PETITION NO: Z-45

PROPOSED USE: Residential Subdivision

STAFF RECOMMENDATIONS

Z-45 (2013)
Stipulation Letter
with Site Plan
and Elevations

EXHIBIT - "A"

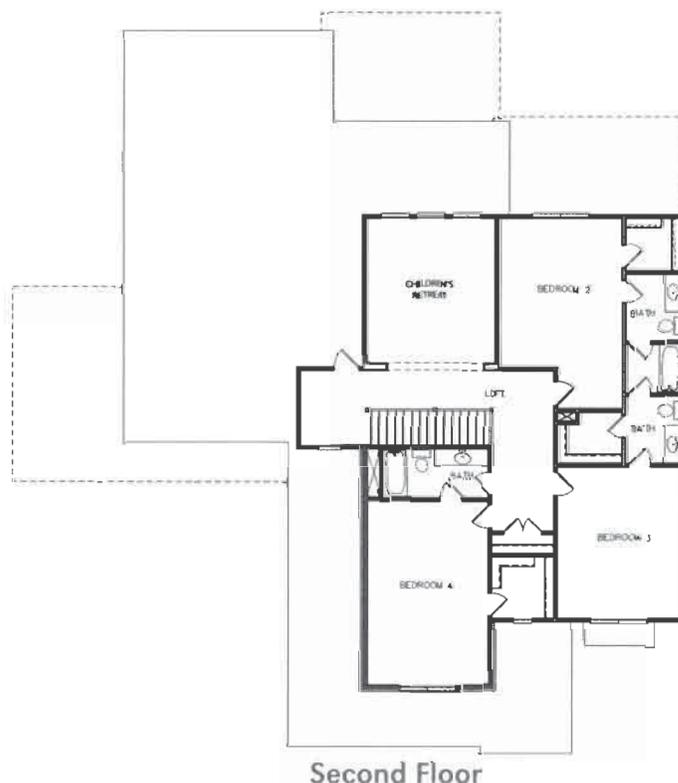
- Provide comprehensive hydrology/stormwater controls to include development of out parcels.
- Submit all proposed site improvements to Plan Review.
- Any **spring activity** uncovered must be addressed by a qualified geotechnical engineer (PE).
- Structural fill _____ must be placed under the direction of a qualified registered Georgia geotechnical engineer (PE).
- Existing facility.
- Project must comply with the Water Quality requirements of the CWA-NPDES-NPS Permit and County Water Quality Ordinance.
- Water Quality/Quantity contributions of the existing lake/pond on site must be continued as baseline conditions into proposed project.
- Calculate and provide % impervious of project site.
- Revisit design; reduce pavement area to reduce runoff and pollution.

- No Stormwater controls shown _____
- Copy of survey is not current – Additional comments may be forthcoming when current site conditions are exposed.
- No site improvements showing on exhibit.

1. This site is predominately wooded with slopes ranging from 10% to 25%. Almost the entire site drains to a small onsite pond located near the southeastern corner of the parcel. The applicant proposes to utilize the existing pond for stormwater management. The dam will need to be brought up to current development standards and the existing water quality and storage effects accounted for as pre-development condition. As part of the subdivision open space, the pond will be maintained by the homeowners association.
2. Although there is a well-defined conveyance from the existing pond through the downstream subdivision (Bishop’s Green) it has very limited capacity. The allowable discharges for the detention pond must account for the downstream capacity limitations and will need to be addressed at Plan Review.

- Site plan received by the Zoning Division on August 16, 2013, with the District Commissioner approving minor modifications;
- Fire Department comments and recommendations;
- Water and Sewer comments and recommendations;
- Stormwater Management comments and recommendations; and
- DOT comments and recommendations.
